Architectural Review Board Agenda 4:00 PM Wednesday, August 6, 2025 Sussex Civic Center – Committee Room Second Floor

MEMORANDUM

RE: August 6, 2025 Architectural Review Board

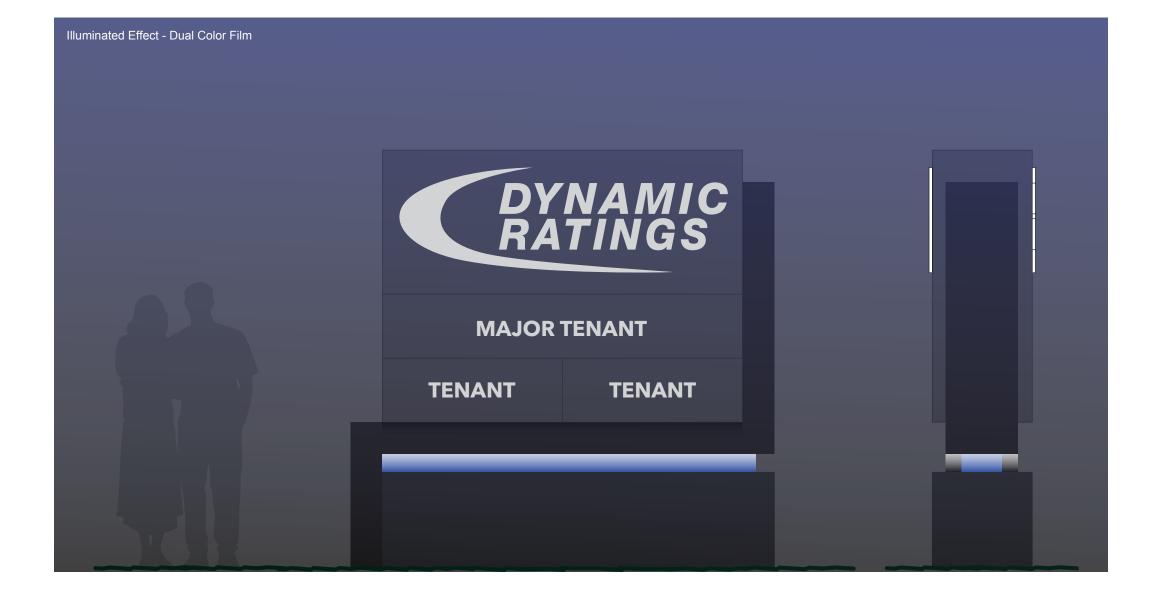
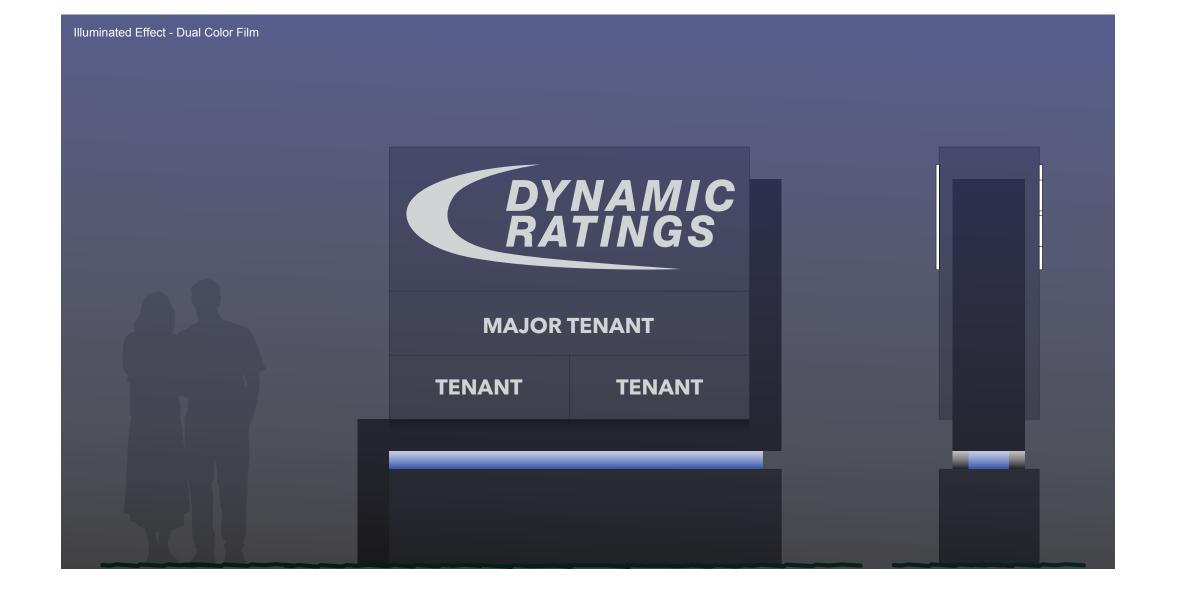
A sign permit application was submitted for Dynamic Ratings for a monument sign for their new building located at the subject property. The Sussex Design Standards require monument signs to be constructed of and framed with natural materials unless otherwise approved by the Architectural Review Board. The applicant has submitted a monument sign, that while being architecturally similar to the building, has an aluminum base and sign cabinet without being framed or constructed of natural materials.

1. The ARB will need to discuss if the Board is comfortable approving the submitted sign although it does not conform to the Sussex Design Standards.

Please view the drawings to note original drawing that Lemberg/Dynamic Rating seeks approval for is a aluminum monument base. The aluminum monument base is cost effective and presents a clean look to the ground sign. The original design has been influenced by the design of the west elevation. Lemberg/Dynamic Rating seeks approval of this design despite the adherence to the natural material requirement.

As a secondary plan, Lemberg/Dynamic Rating presents a second option. The second option is very similar in color, size, and design – however the base is now a concrete base that will be painted. This has been designed to honor the original design while also complying with the natural material ARB requirement. Please note, with this intentional design to match the building, it is difficult to have the natural material surrounding the sign cabinet.

Staff Recommendation: Staff recommends the ARB discuss the proposed signage and take action on the submitted sign application.

2025-065 A1

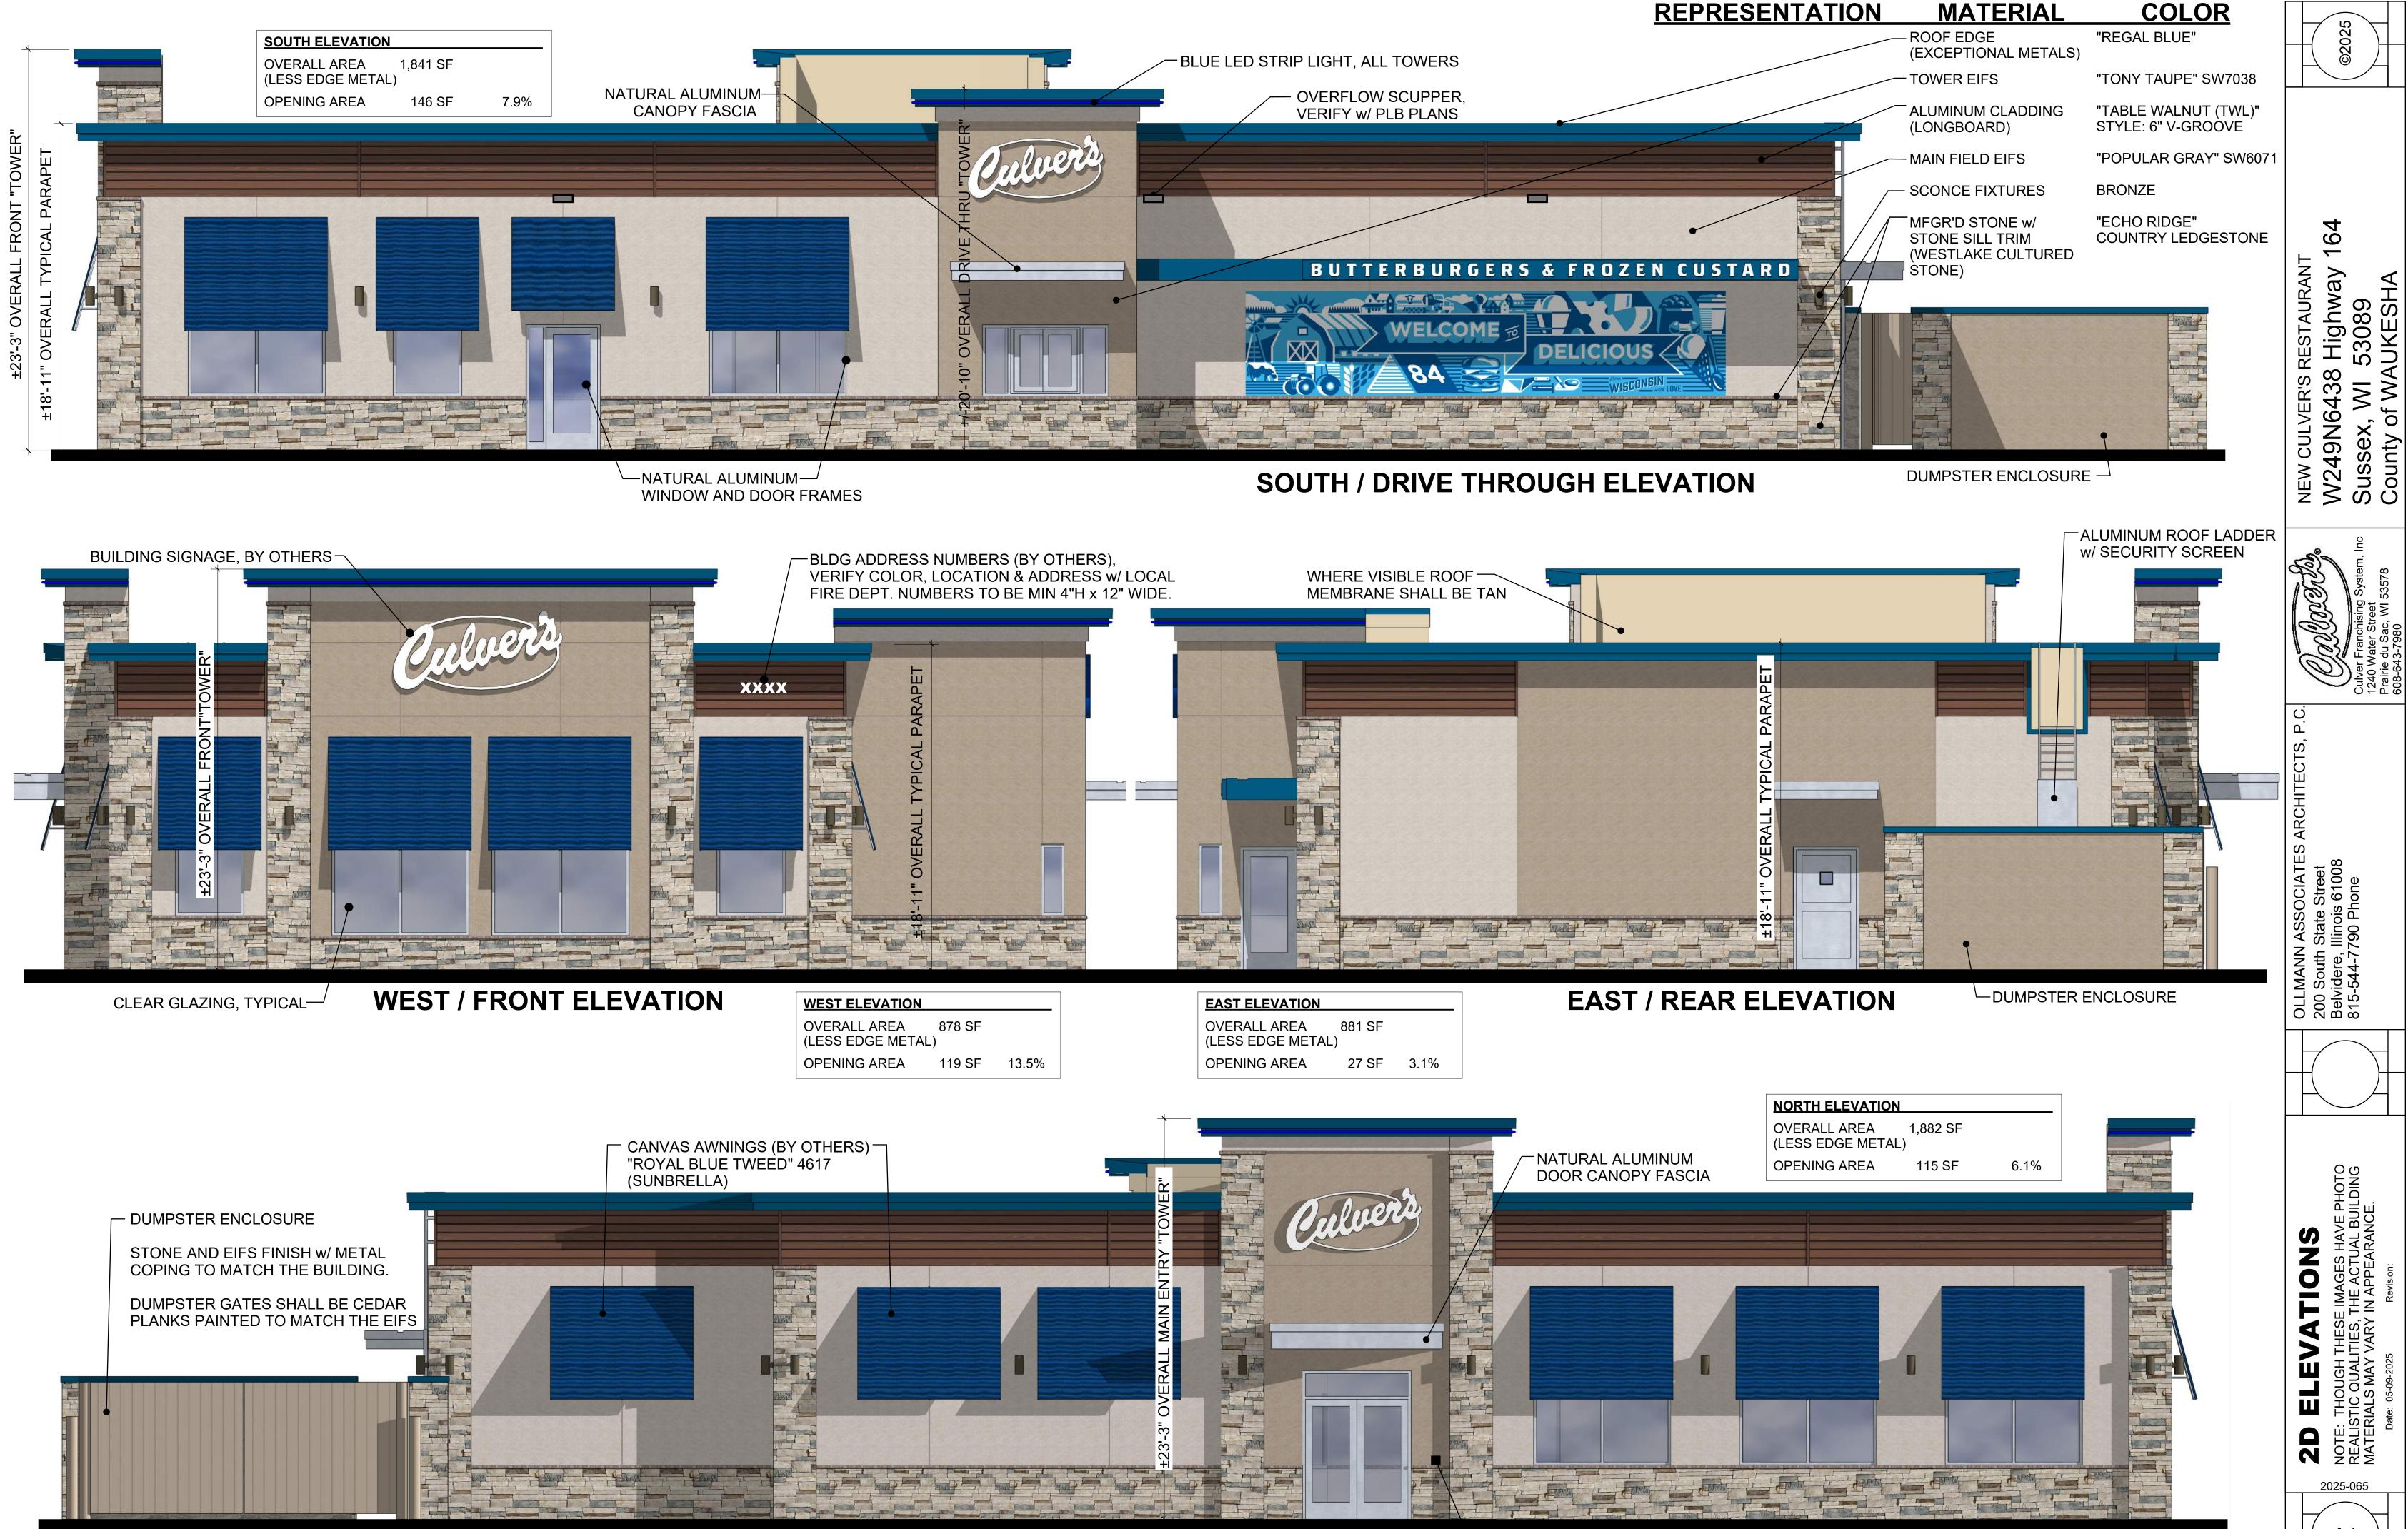
- 1. Are there any concerns with the submitted site plans?
- 2. The submitted plans do not meet the minimum 33% window/door opening on the street elevation facing STH 164. The applicant will need to request a waiver from this and will need to be approved by the ARB and Plan Commission.

- 1. Submitting a revised site plan with details for amount of greenspace.
- 2. Light fixture mounting height shall not exceed 25'.
- 3. Submitting revised elevations for the west side that meets the minimum 33% window and door opening requirements.
- 4. Submitting a revised landscape plan that includes lists hardwood mulch rather than stone mulch
- 5. Light pole bases shall be painted to match the building. Submit details to Staff for review.

A200

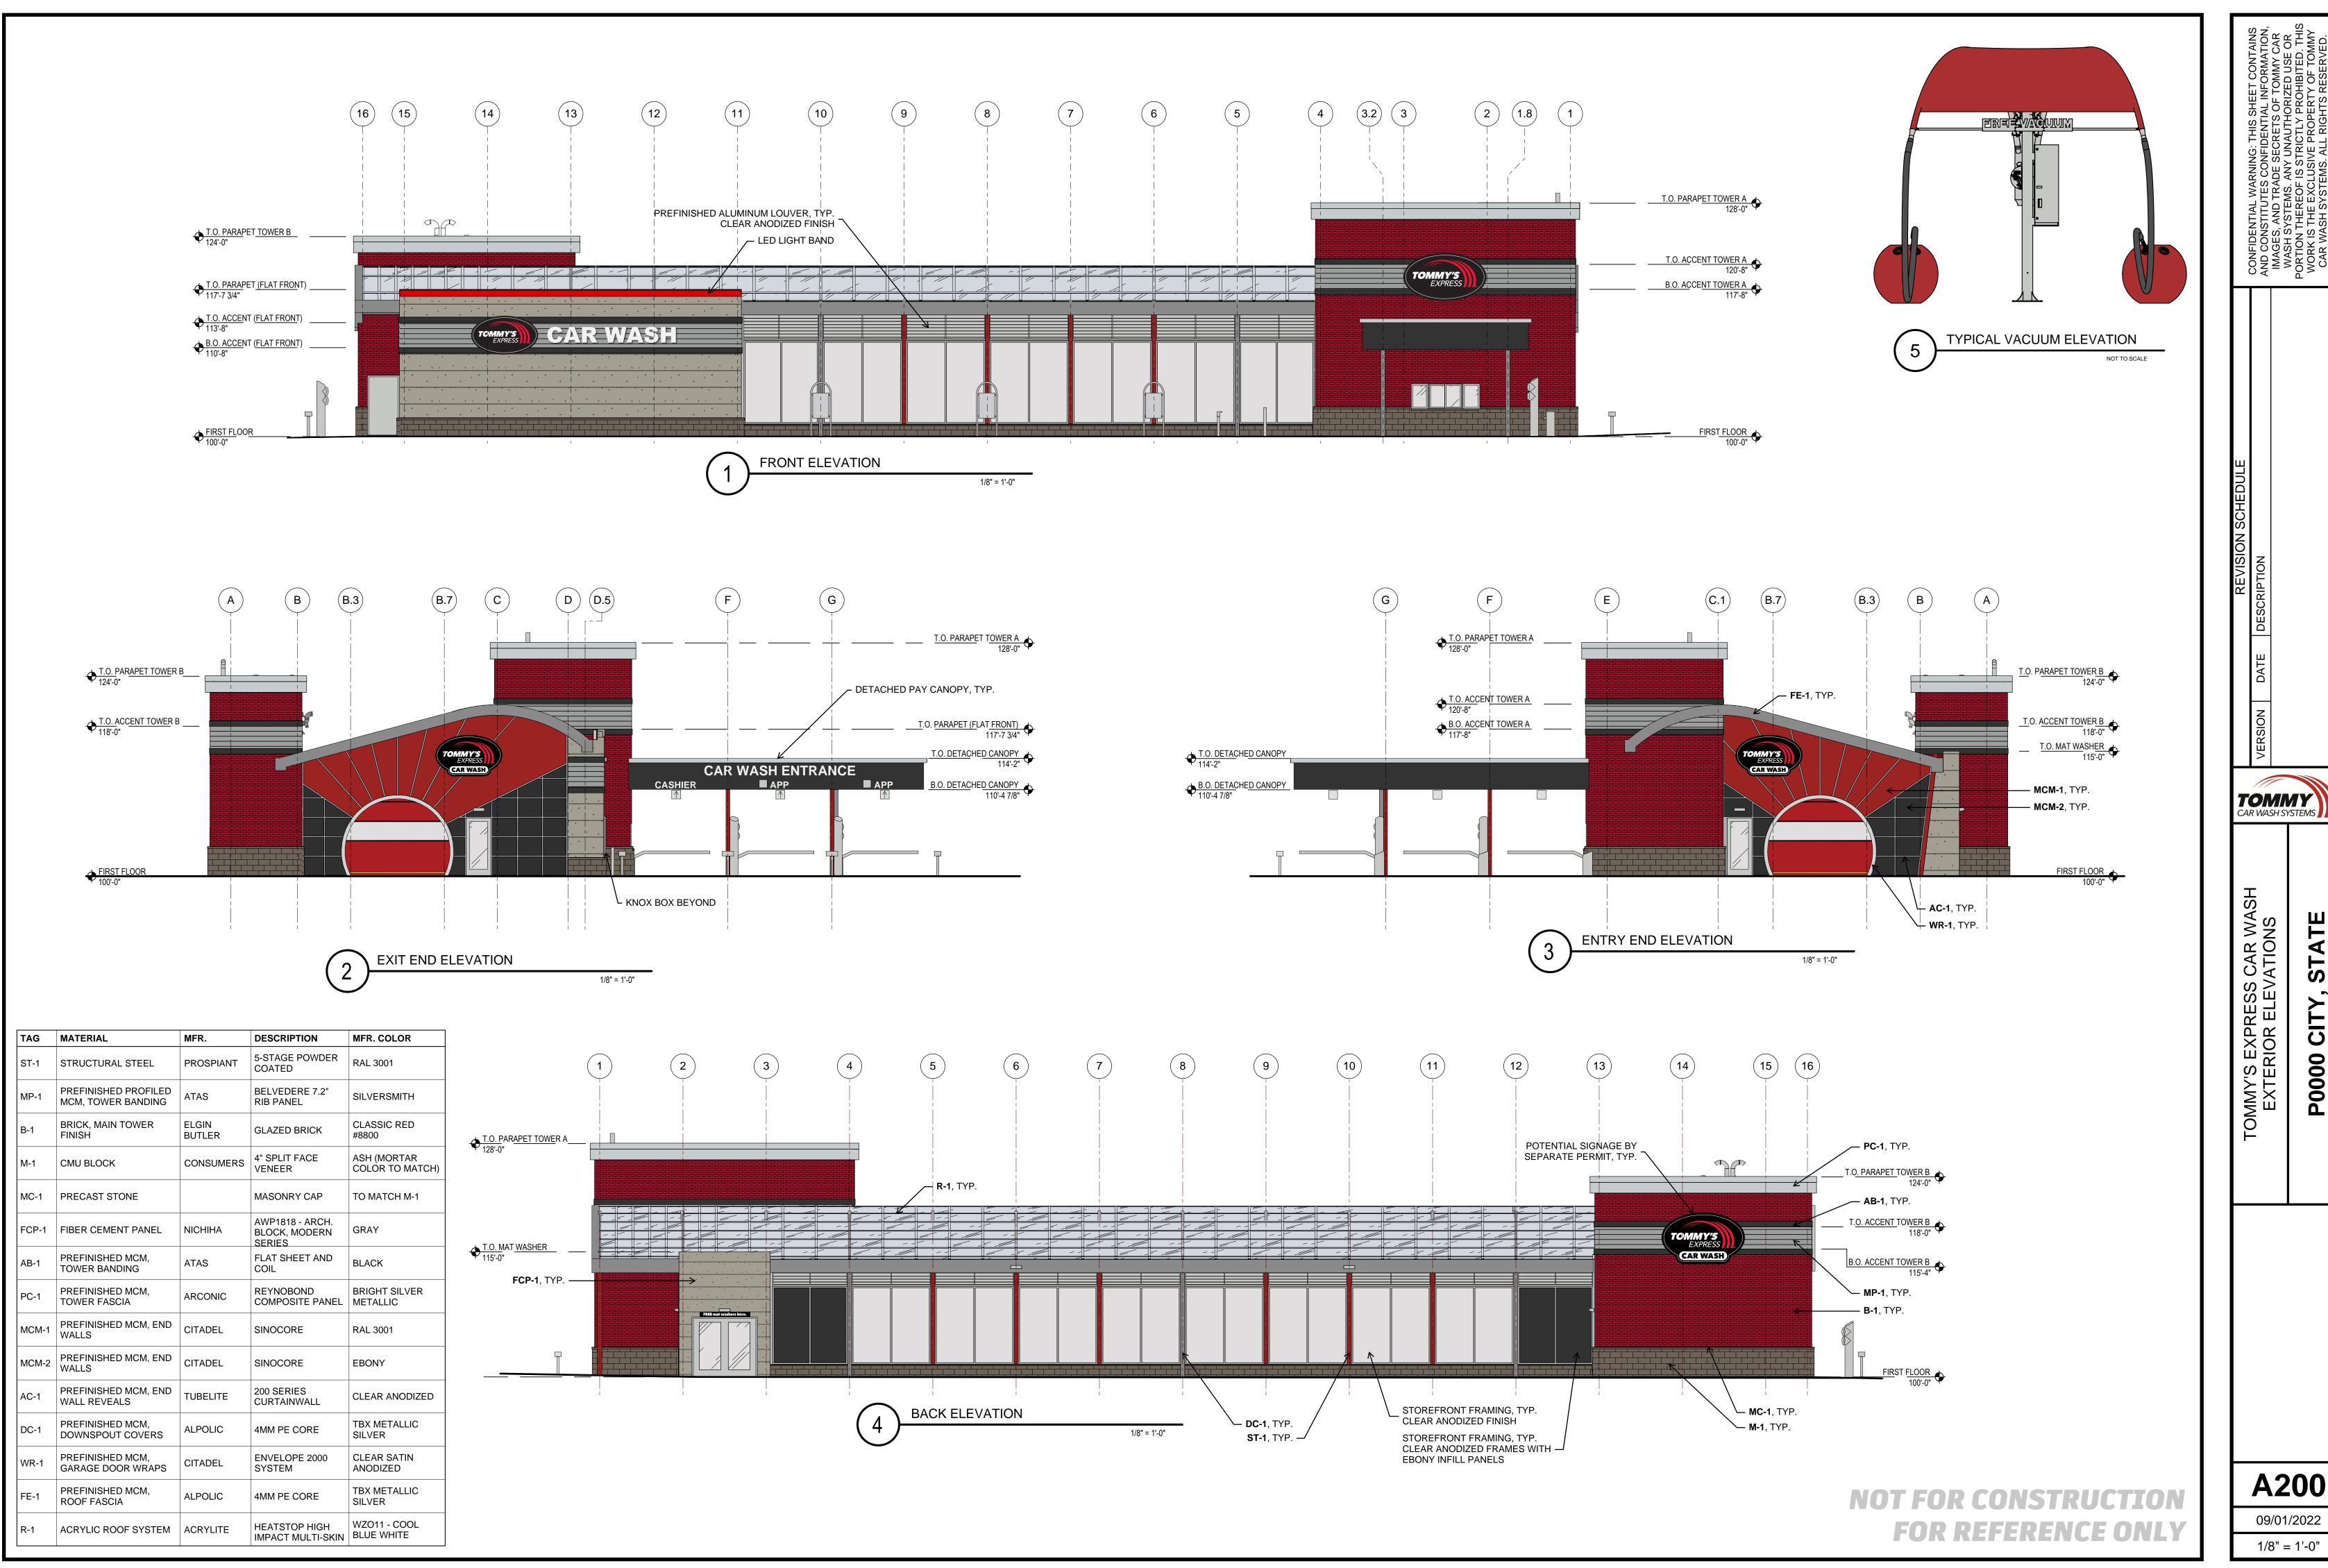
- 1. Are there any concerns with the submitted site plans?
- 2. It appears the submitted plans do not meet the minimum 33% window/door opening on the street elevation facing STH 164. The applicant will need to request a waiver from this and will need to be approved by the ARB and Plan Commission.

- 1. The Plan Commission approving the Conditional Use Permit for the proposed Tommy's Car Wash.
- 2. Submitting a revised lighting plan that meets the requirements of the Municipal Code to Staff for review.
- 3. Submitting revised elevations that meet the minimum window/door opening requirements to Staff for review or request an exception from the Design Standards.
- 4. Submitting a revised landscape plan that includes hardwood mulch rather than stone mulch to Staff for review.
- 5. Submitting elevations that include the trash enclosure and properly label the materials on the building with the corresponding material key for Staff to review.
- 6. Light pole bases shall be painted to match the building and details submitted to Staff for review.
